**BOULDER COUNTY PLANNING COMMISSION
PUBLIC HEARING**

STAFF RECOMMENDATION

Docket SU-21-0013: Butte Blacksmith LLC Repair Garage

Request: Special Use Review to allow for two principal uses (Vehicle Sales/Rental Lot and General Industrial) on the parcel, as well as 2,390-cubic-yards of non-foundational grading, deconstruction of a 2,786-square-foot repair garage, 530-square-foot mobile home, 64-square-foot shed, and 40-square-foot shed, construction of a 9,344-square-foot repair garage, and conversion of an existing 904-square-foot residence to an office use associated with the repair garage on a 1.76-acre parcel.

Revised Site Plan (Current) - April 19, 2023

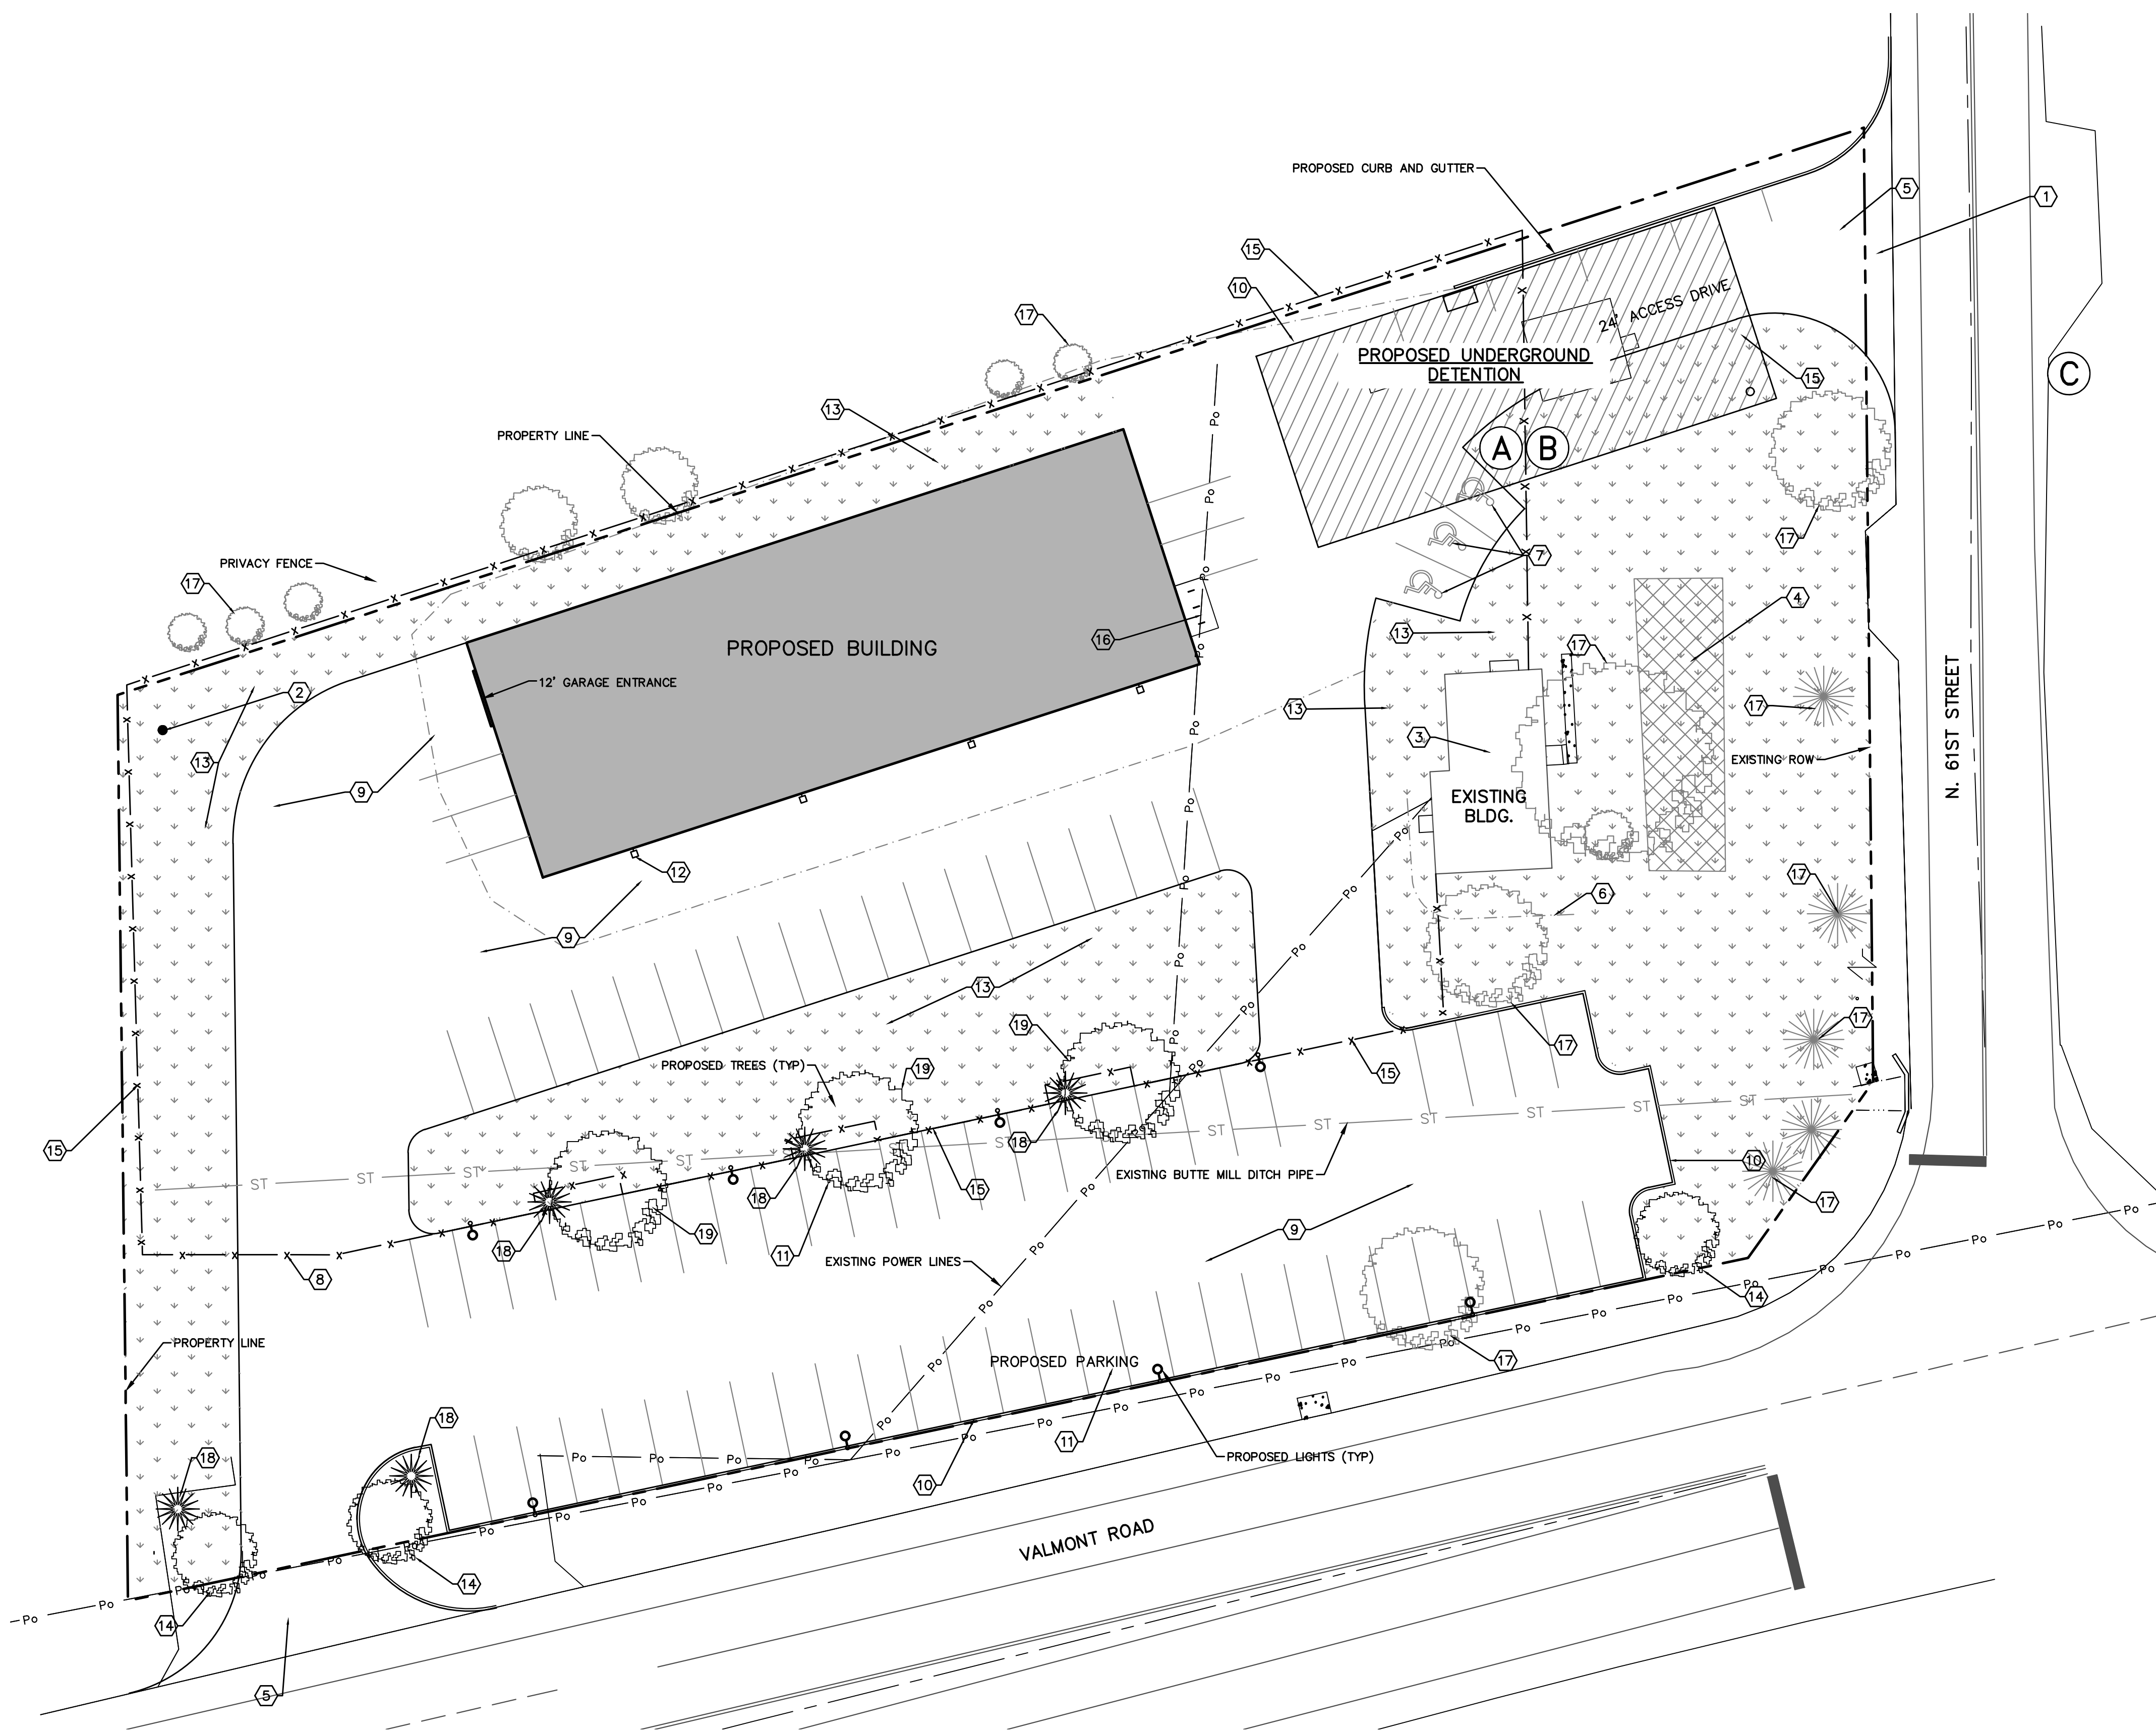
The site plan dated April 19, 2023 does not indicate which parking spots will be used for customer or employee parking. Staff has determined it is necessary for there to be designated parking spots for customers and employees to help ensure that vehicles are not parked in access aisles or travel lanes on site. If customers or employees were to park in access aisles or travel lanes, it would pose a safety hazard as it could impair the ability of emergency services to access the site. As such, staff recommends as a condition of approval that plans submitted for permitting must clearly identify a minimum of 10 parking spots for customer and employee parking; at least four (4) of these must be for customers. All customer and employee parking must be signed for customer or employee use, must remain clear and unencumbered for customer and employee use, and may not be used for parking of vehicles for sale or repair. Required Americans with Disabilities Act (ADA) accessible parking shall not be counted toward the required customer and employee parking. Based on discussions with the applicant, 10 customer and employee parking spaces are sufficient for this proposal, as it is unlikely for there to be more than two (2) or three (3) customers on site at any one time and typically staff would include only one (1) or two (2) salespersons and five (5) repair technicians. Staff recommends as an additional condition of approval that no parking or storage of vehicles shall be allowed in any access aisles or travel lanes.

Additionally, both proposed uses are required to provide one (1) loading space for each 10,000 square feet of floor area. As such, for both uses, a total of four (4) loading spaces are required. The site plan dated April 19, 2023 does not identify specific loading spaces; however there is a sufficient number of the parking spots for the applicant to meet the loading space requirement. To ensure that the required loading spaces are available on site, staff recommends as a condition of approval that the plans submitted for permitting identify the spaces to be reserved as loading spaces, and that those spaces be appropriately signed as loading spaces.

2. Plans submitted for permitting must clearly identify a minimum of 10 parking spots for customer and employee parking; at least four (4) of these must be for customers. All customer and employee parking must be signed for customer or employee use, must remain clear and unencumbered for customer and employee use, and may not be used for parking of vehicles for sale or repair. Required Americans with Disabilities Act (ADA) accessible parking shall not be counted toward the required customer and employee parking.

3. No parking or storage of vehicles shall be allowed in any access aisles or travel lanes.
4. Plans submitted for permitting must clearly identify the four (4) spaces to be reserved as loading spaces; these spaces must be appropriately signed as loading spaces.

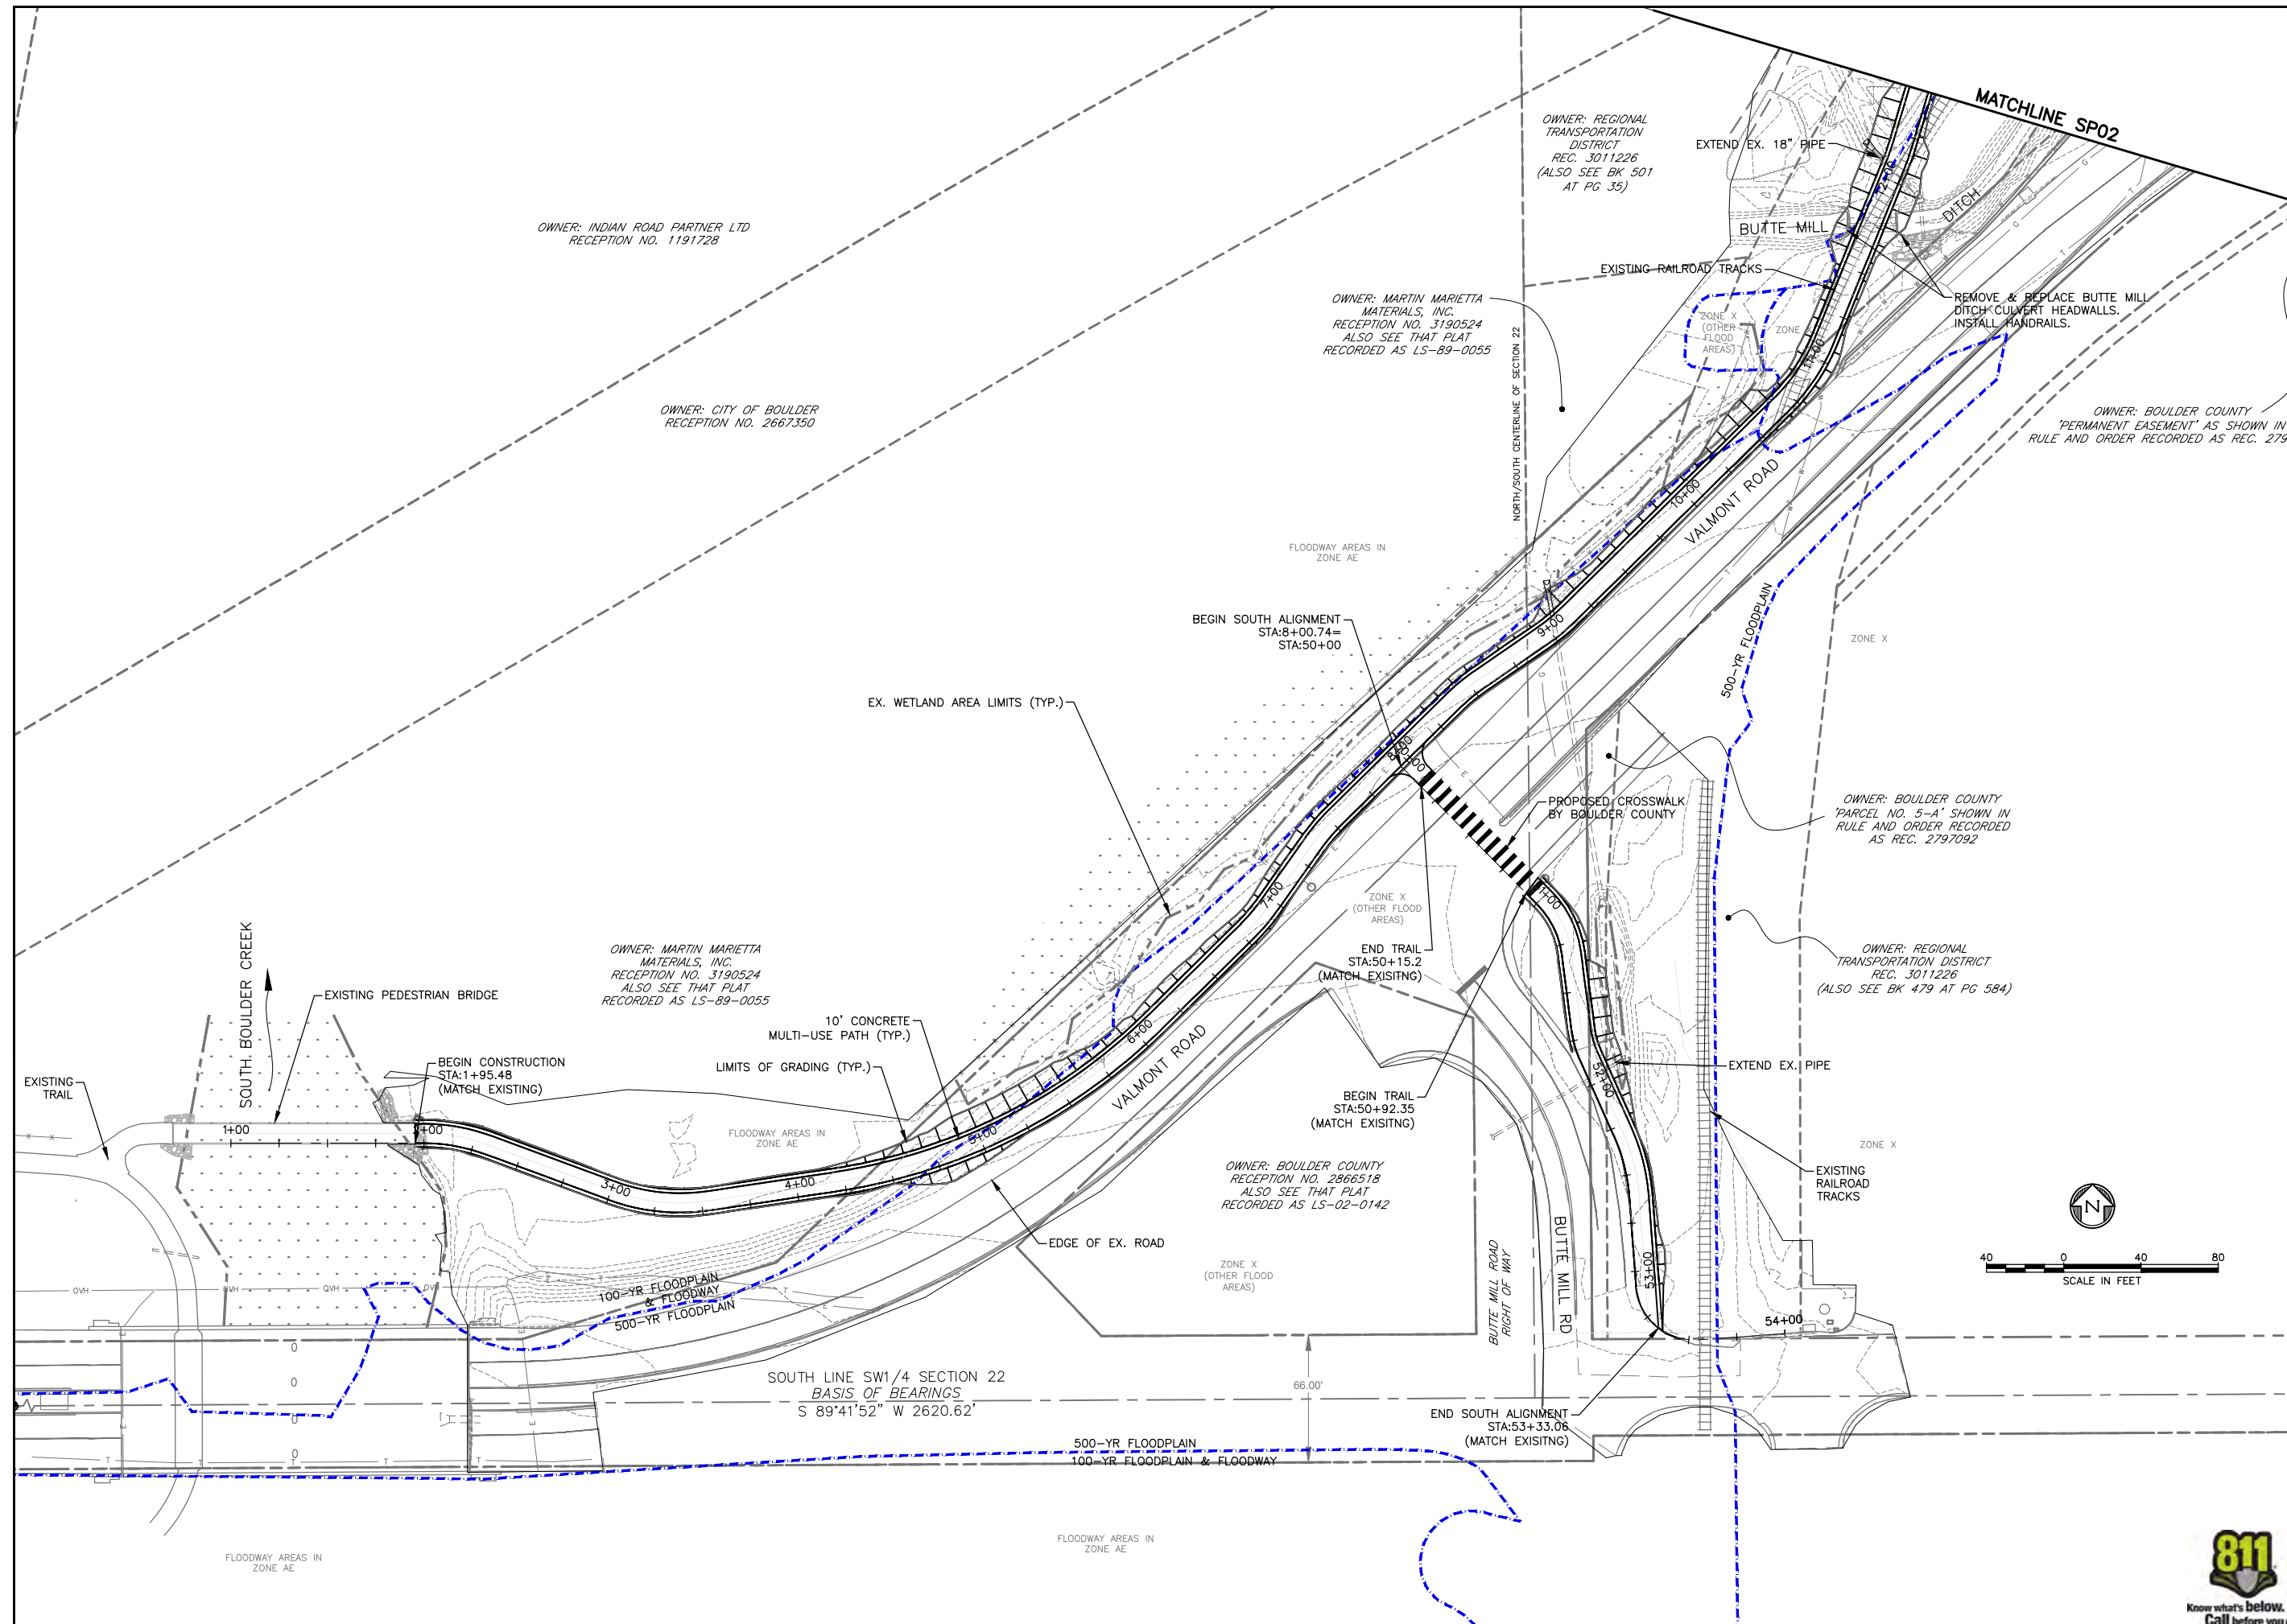
The City is currently coordinating with Boulder County and the Regional Transportation District (RTD) to construct a multi-use path in the RTD ROW located on the north property line of the subject property. The path is currently planned to be located on the north side of the existing railroad tracks. (See attached plan sheet.)

The proposed access for the multi-use path from 61st St. is proposed to be located on the northeast corner of the subject property. The multi-use path will have a crossing of 61st St. somewhere within the RTD ROW located in this general location. This crossing of 61st St. will likely require a median island in 61st St. at the crossing location. The proposed path crossing of 61st St. will connect the planned City of Boulder multi-use path (west of 61st St.) to the proposed Rail to Trail path proposed by Boulder County (the east of 61st St.). Matt Wempe of Boulder County Transportation is managing the Rail to Trail project.
